VALUE ENGINEERING CHANGE PROPOSAL
MISSOURI DEPARTMENT OF TRANSPORTATION

Contract ID 100205-601 **Job No.** J6U0807

VECP# 11-76 **(to be completed by C.O.)** **VECP** ☒ **or** **PDVECP** ☐

Existing Requirements/Proposed Changes:
Construct Post & Panel Wall A7807 between relocated Post Rd and Proposed Rt. 141 from STA 256+56 to STA 262+00 (see detail on attached Typical Section Sheet 2 of 15).

TYPICAL SECTION
ALTERNATE A
(RIGID PAVEMENT)
SHEET 2 OF 15

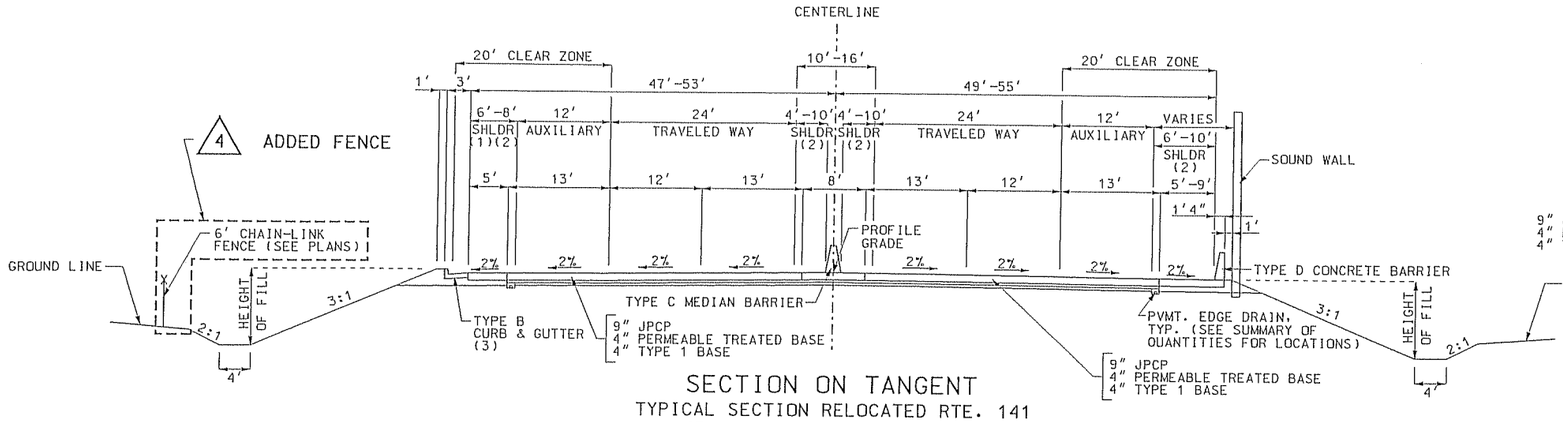
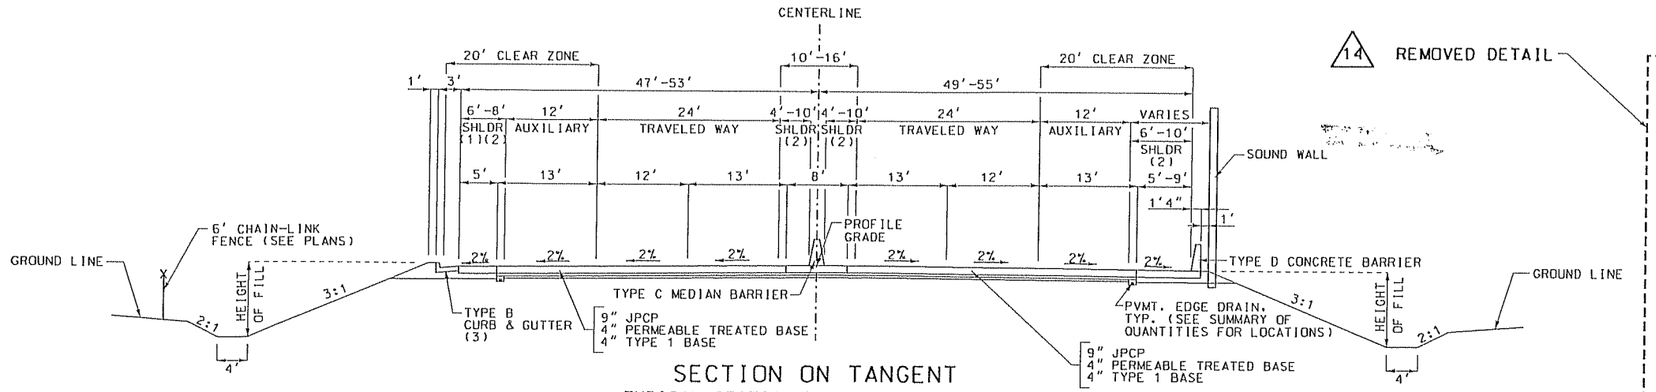
Proposed Change:
Modify configuration of relocated Post Rd so that edge of Post Rd is outside of permanent wall easement. Slope can then be extended down to limits of permanent easement, eliminating the need for retaining wall A7807. A ground mount soundwall can be constructed between Soundwalls 8 & 9 at the top of the slope adjacent to Proposed Rt. 141 pavement (see details on attached revised Typical Section Sheet 2 of 15).

ROUTE 141 CONSTRUCTION PLAN
STA 251+00 TO STA 264+00

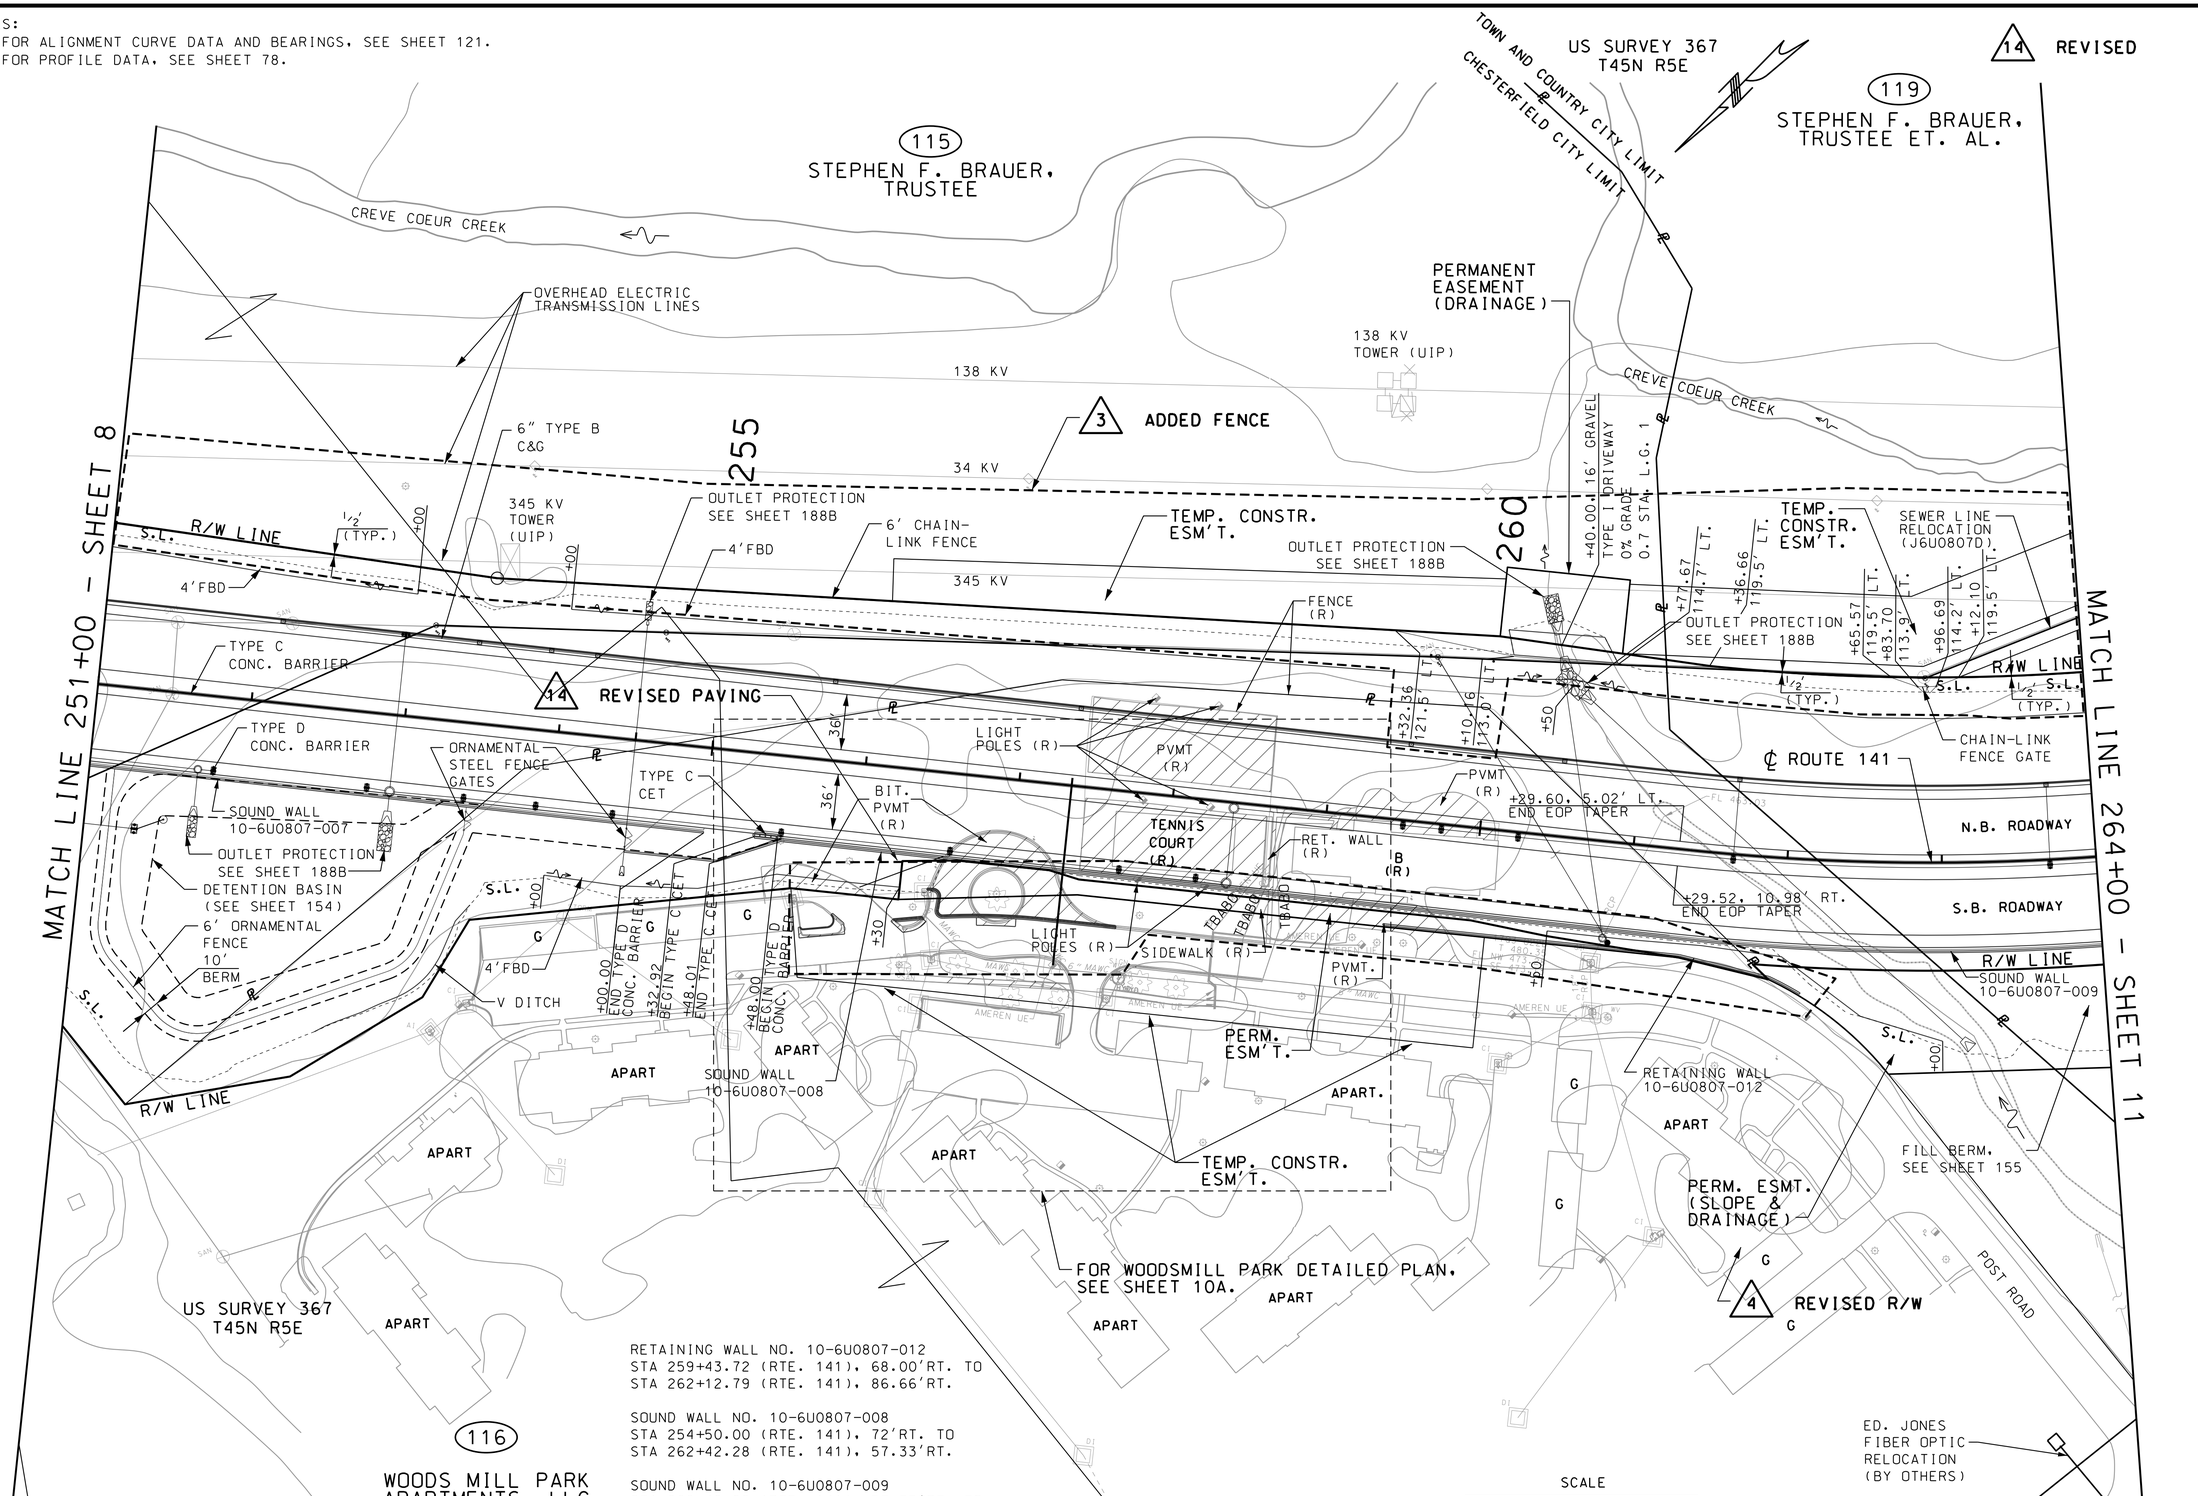
Post Road will be slightly realigned to eliminate need for retaining wall.
